RECORD PLANS

PROPOSED IMPROVEMENT
 BRIDGE PROJECT

PROJECT NAME: MENDON
 PROJECT NUMBER: BRO 1443(43)

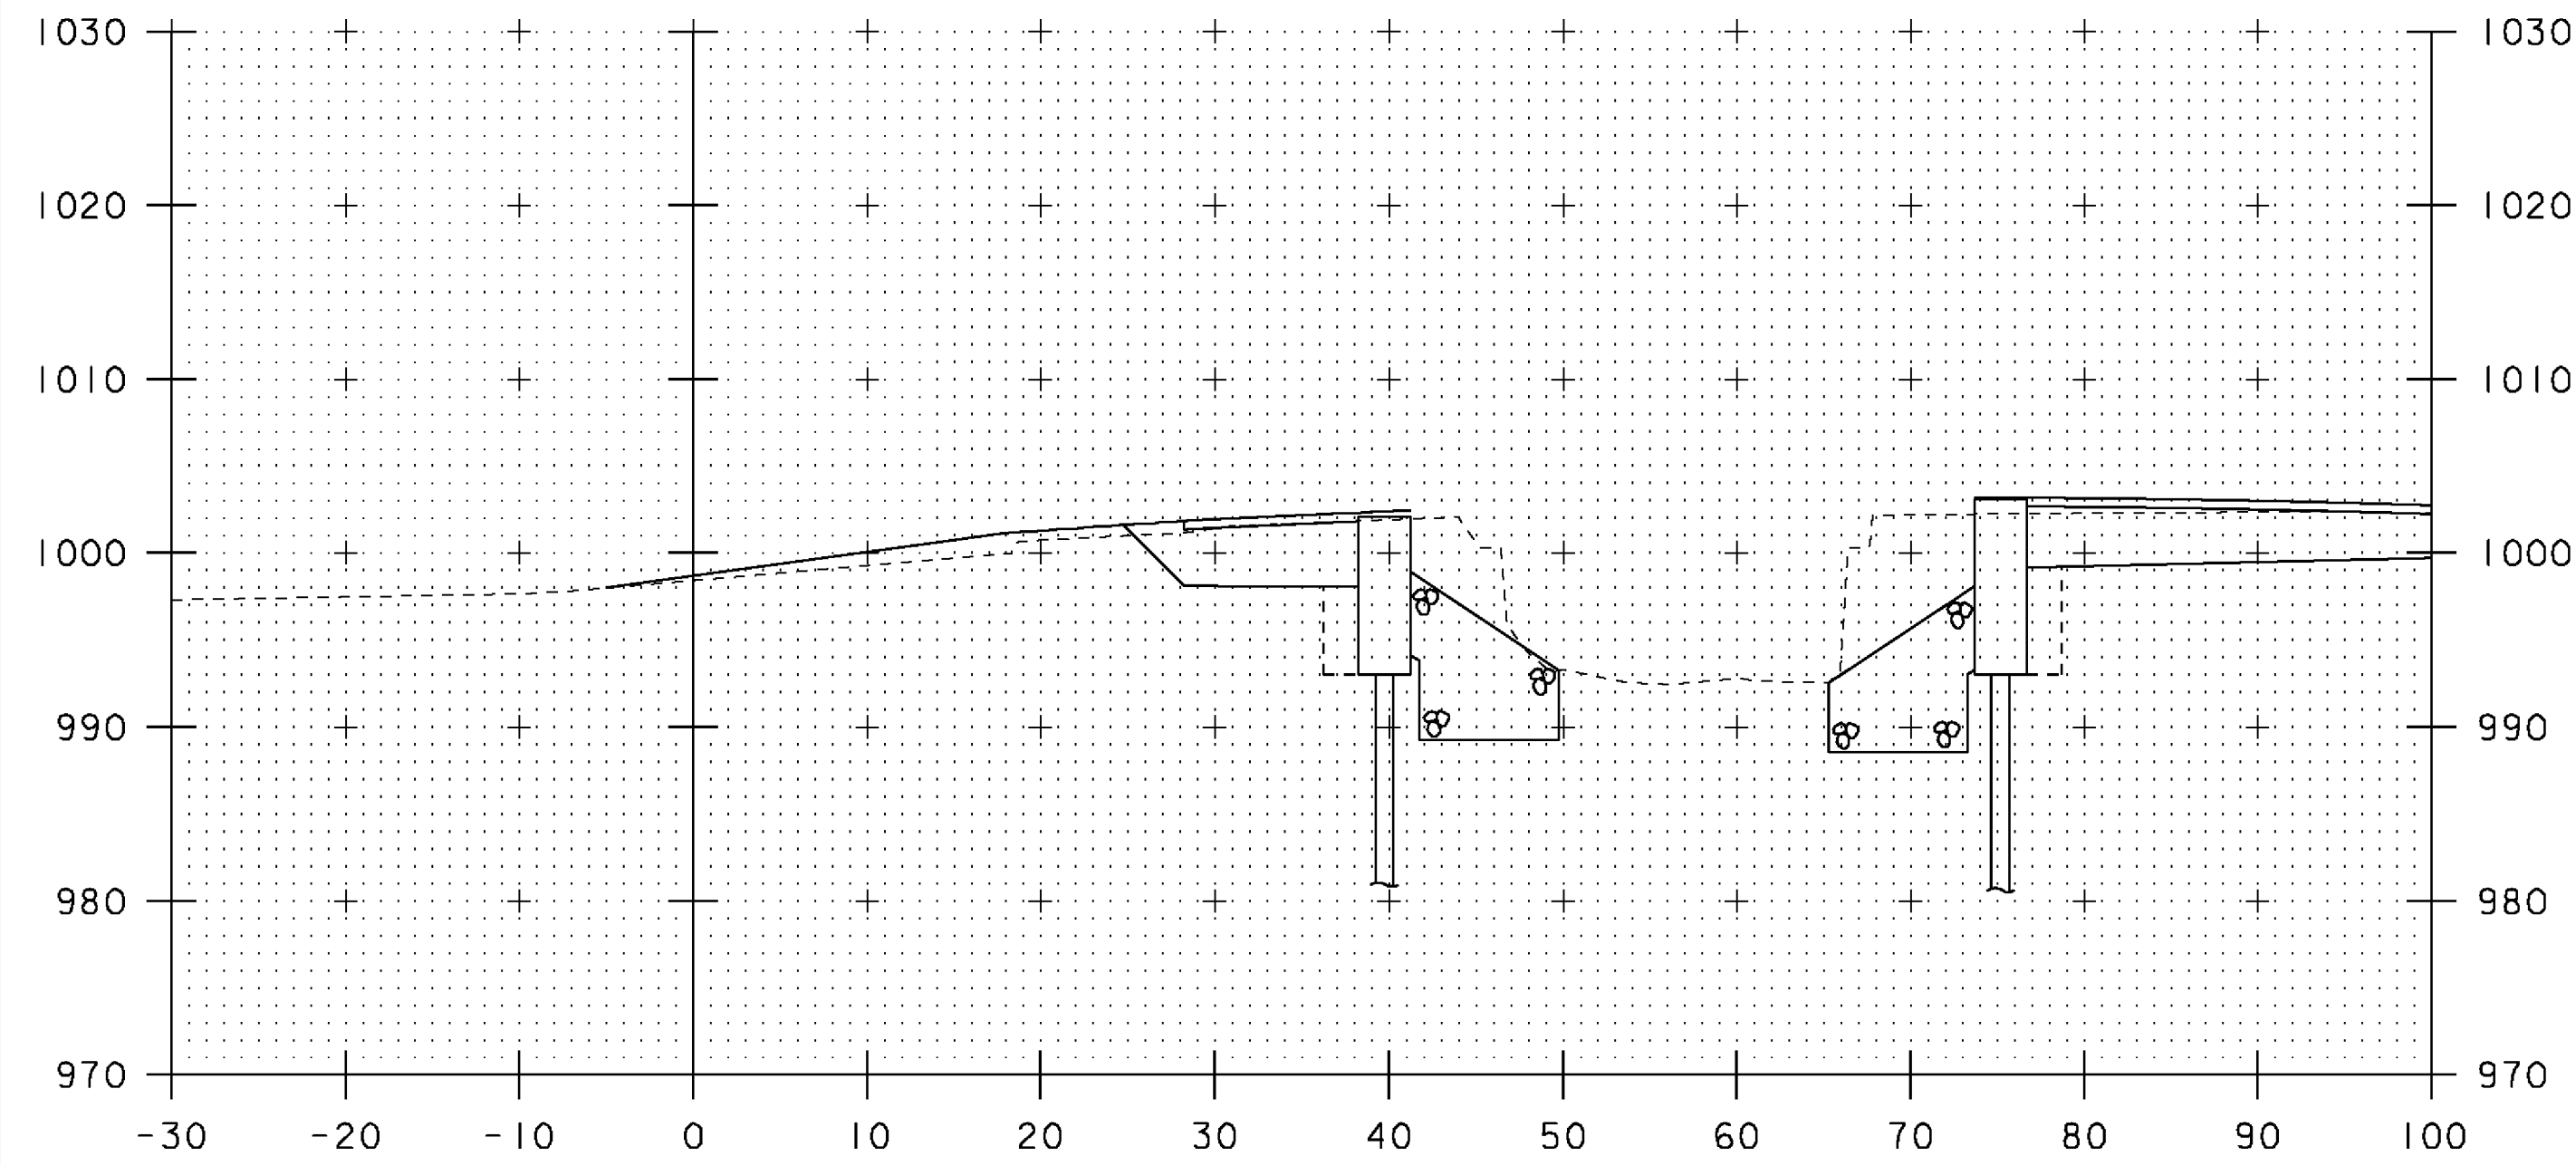
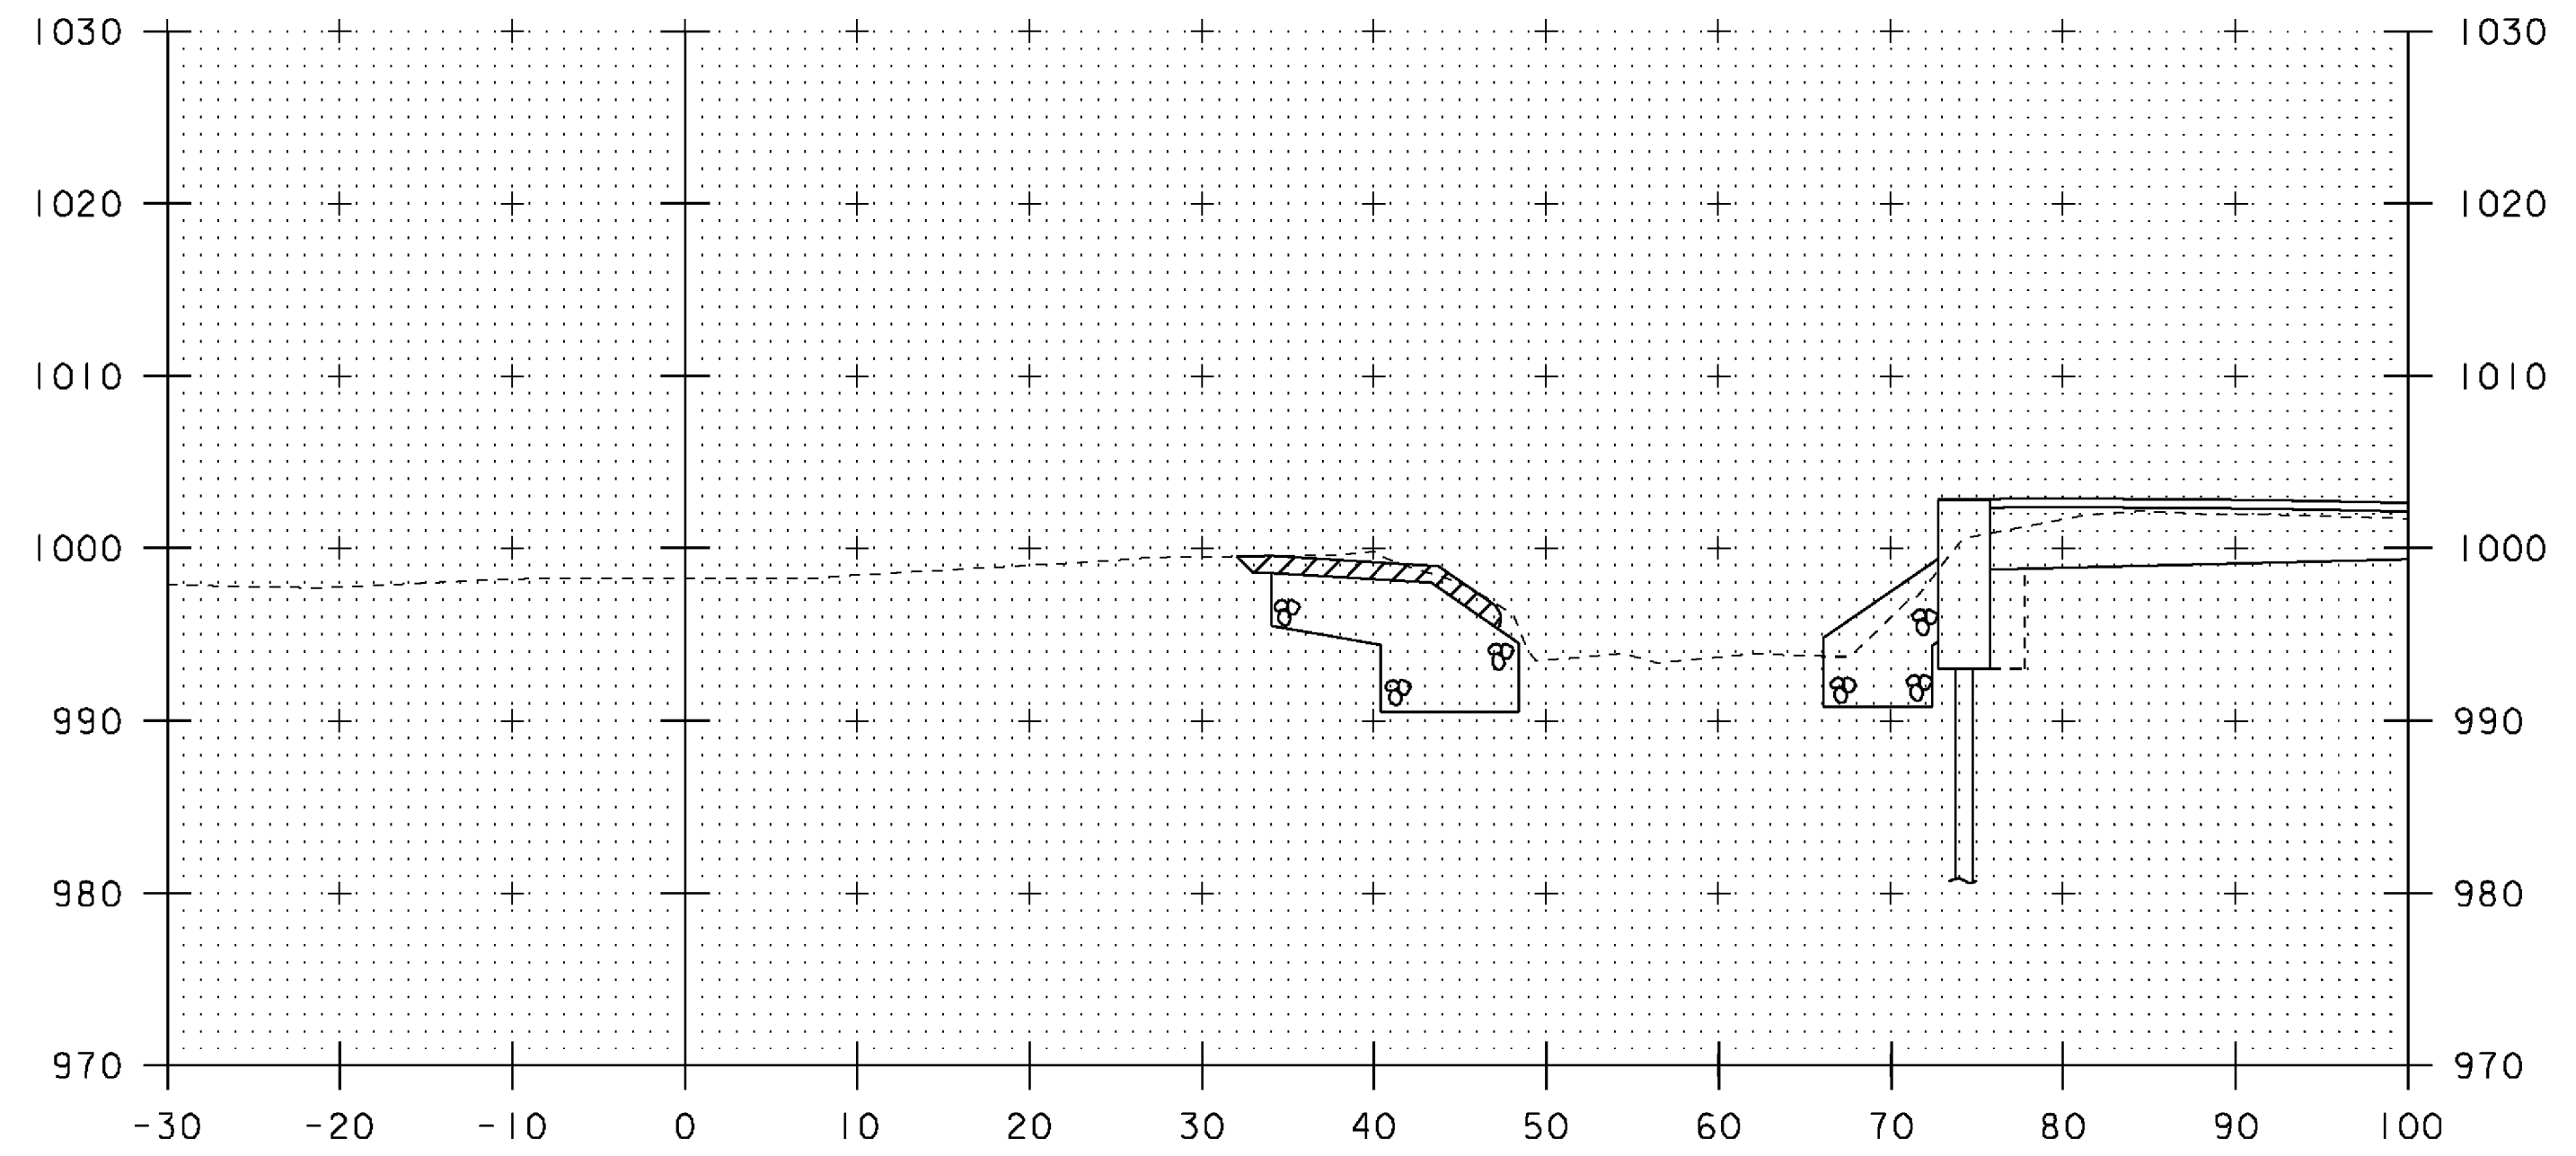
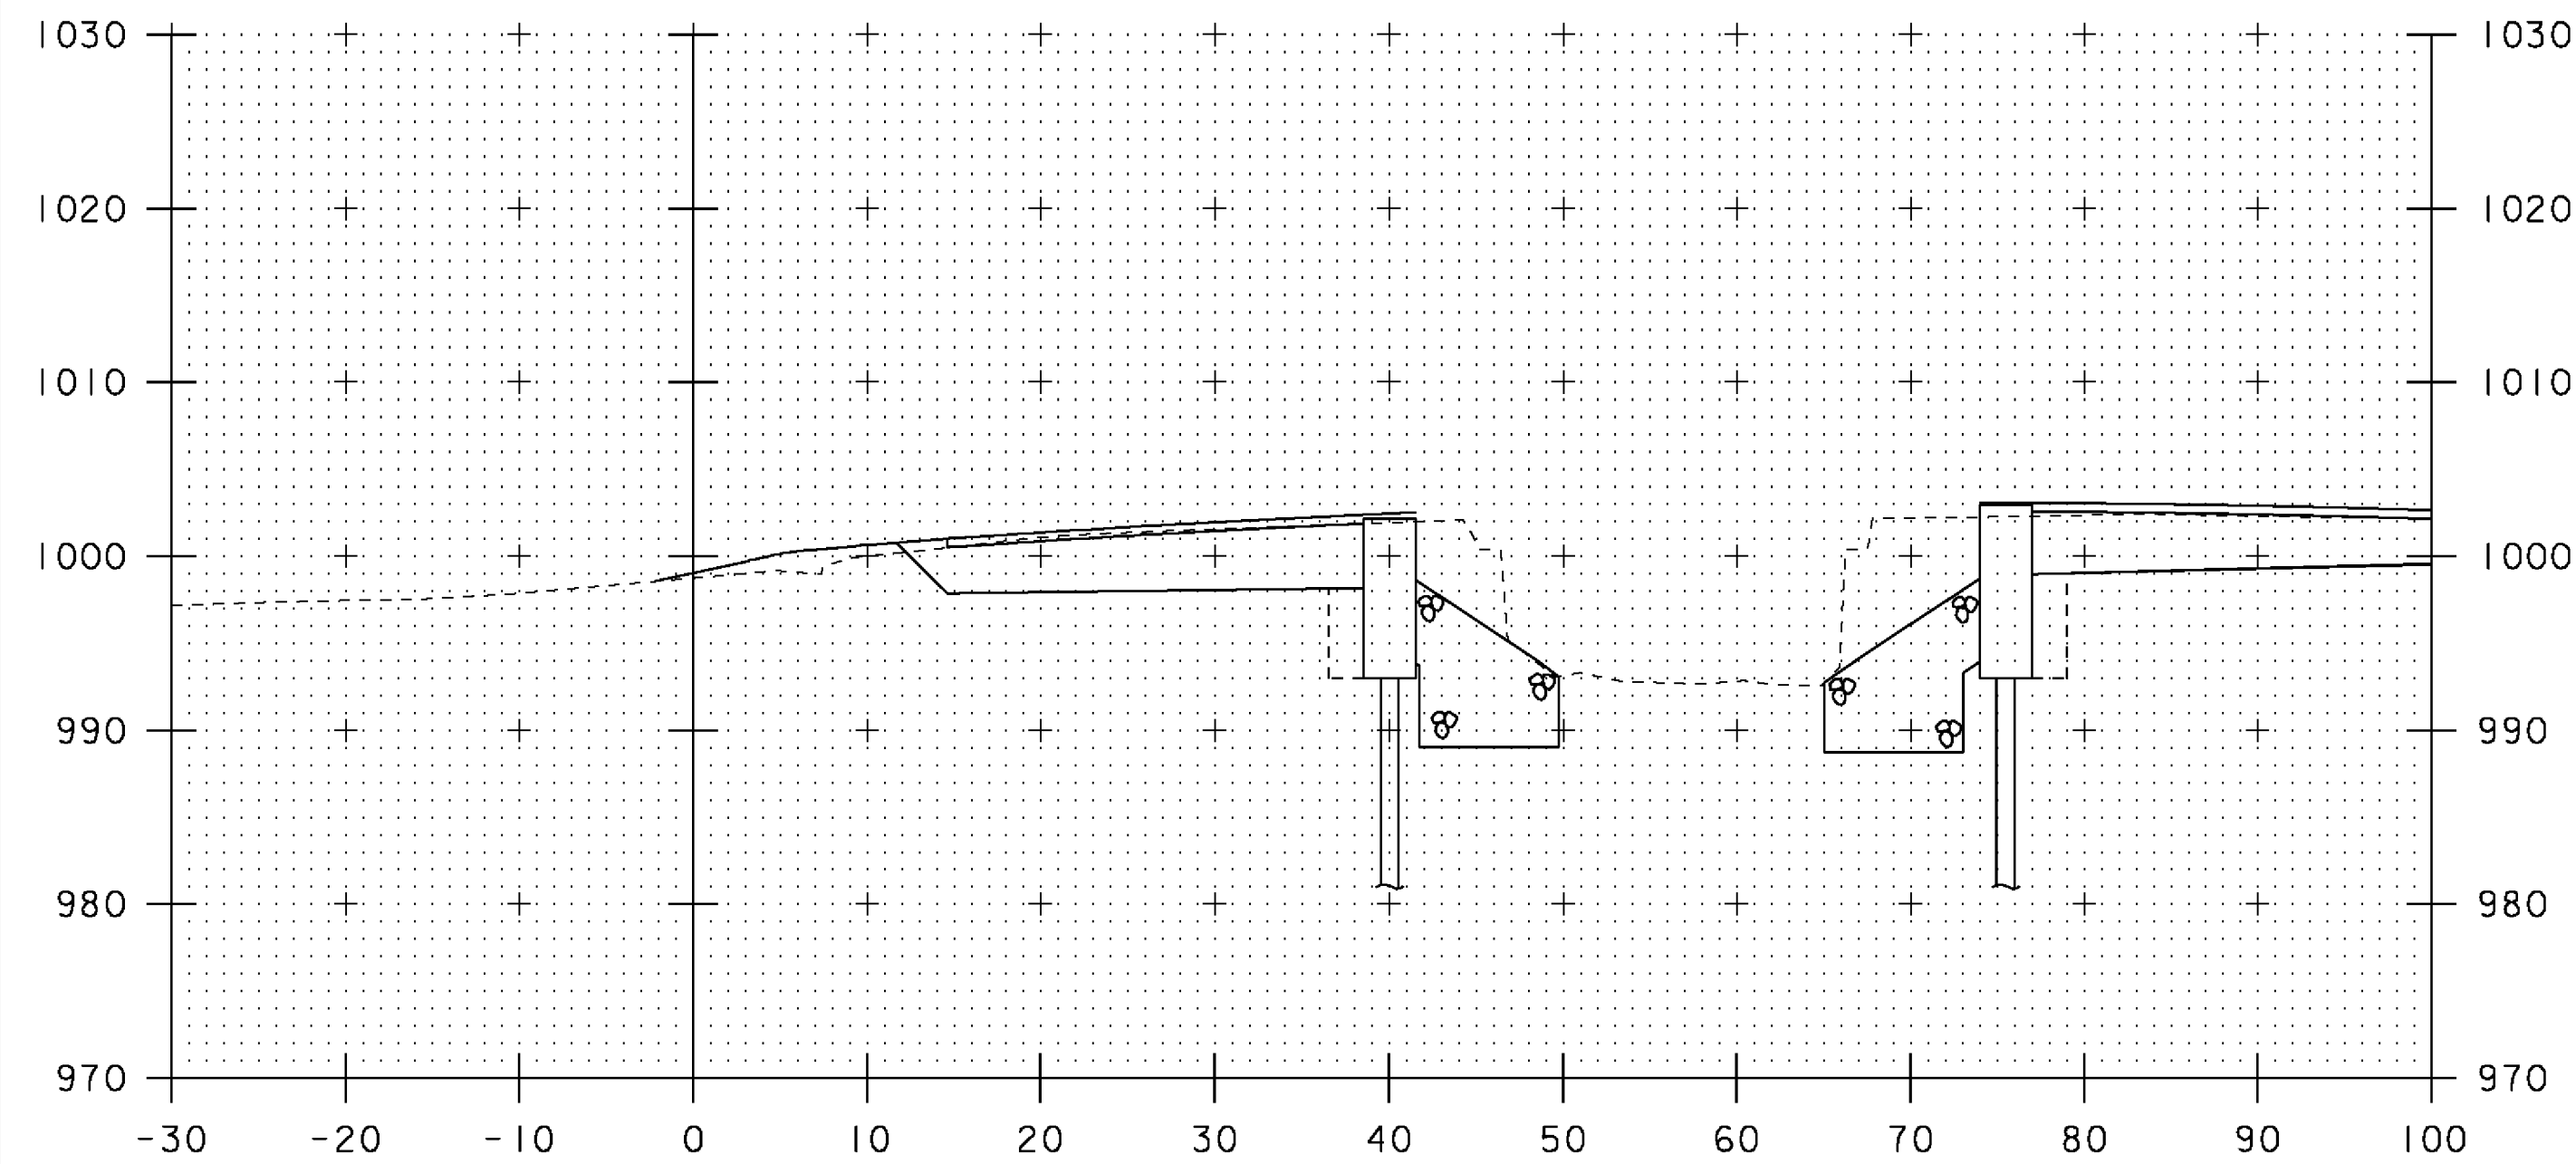
EXISTING GROUND NO LONGER VALID SINCE IRENE 8-28-II.
 NEW SURVEY REQUIRED FOR CHANNEL SECTIONS
 (TYP ALL SHEETS 31 & 32).
